DESIGN <i>LE</i>	DRAWN BY <i>LE</i>	DART AEROSPACE LTD HAWKESBURY, ONTARIO, CANADA	
CHECKED <i>GP</i>	APPROVED <i>[Signature]</i>	DRAWING NO. DSI 9351	REV. A SHEET 1 OF 1
DATE 06.09.15		TITLE SHOULDER HARNESS KIT SCALE NTS	
REV A	DATE 06.09.15	DESCRIPTION NEW ISSUE

DART SERVICE INSTRUCTION

TO AMEND INSTALLATION INSTRUCTIONS IIN-D412-702 REV A, B OR C
REF. CANADIAN STC SH04-7
REF. FAA STC SR01997NY

FIGURE 1. KIT INSTALLATION ON CENTRAL PANEL

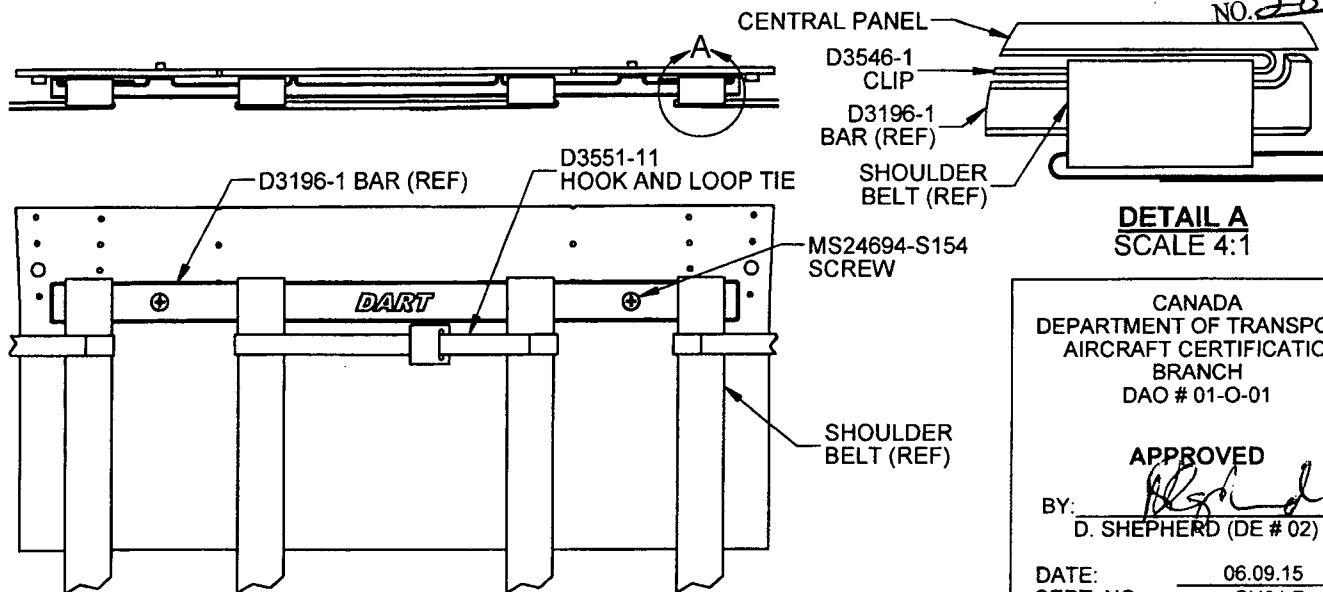
TO IMPROVE THE FIT AND VISUAL IDENTIFICATION OF SHOULDER HARNESS SETS, DSI 9351-011/-013/-015 SHOULDER HARNESS UPGRADE KITS ARE AVAILABLE FOR THE D412-702-011/-021/-013/-023/-015/-025/-017/-027 AND D214-702-035 SHOULDER HARNESS KITS AT CHANGE 1. INSTALLATION OF THESE KITS IS OPTIONAL.

1) REMOVE THE MS24694-S152 SCREWS FROM THE D3196-1 BAR ON THE CENTRAL PANEL. RE-INSTALL THE D3196-1 BAR WITH D3546-1 CLIPS USING MS24694-S154 SCREWS AS SHOWN IN FIGURE 1. ENSURE THAT THE SHOULDER BELTS ARE LOOPED THROUGH THE CLIP AS SHOWN IN DETAIL 'A'. TORQUE SCREWS TO 100-140 in-lbs (11.3-15.8 N-m). IT IS ACCEPTABLE TO USE LONGER MS24694-SXXX SCREWS AS REQUIRED TO ENSURE THAT THE D3196-1 BAR IS PROPERLY SECURED.

2) INSTALL THE D3551-11 HOOK AND LOOP TIES THROUGH THE FRONT LOOPS OF EACH SET OF SHOULDER BELTS. INSTALLATION ON THE 4-MAN AFT FACING BENCH IS AT THE DISCRETION OF THE INSTALLER. ENSURE THAT THE 'LOOP' SIDES OF THE TIES ARE FACING OUTWARD FOR PASSENGER COMFORT. TIGHTEN OR LOOSEN THE TIES AS NEEDED (TRIMMING IS ACCEPTABLE).
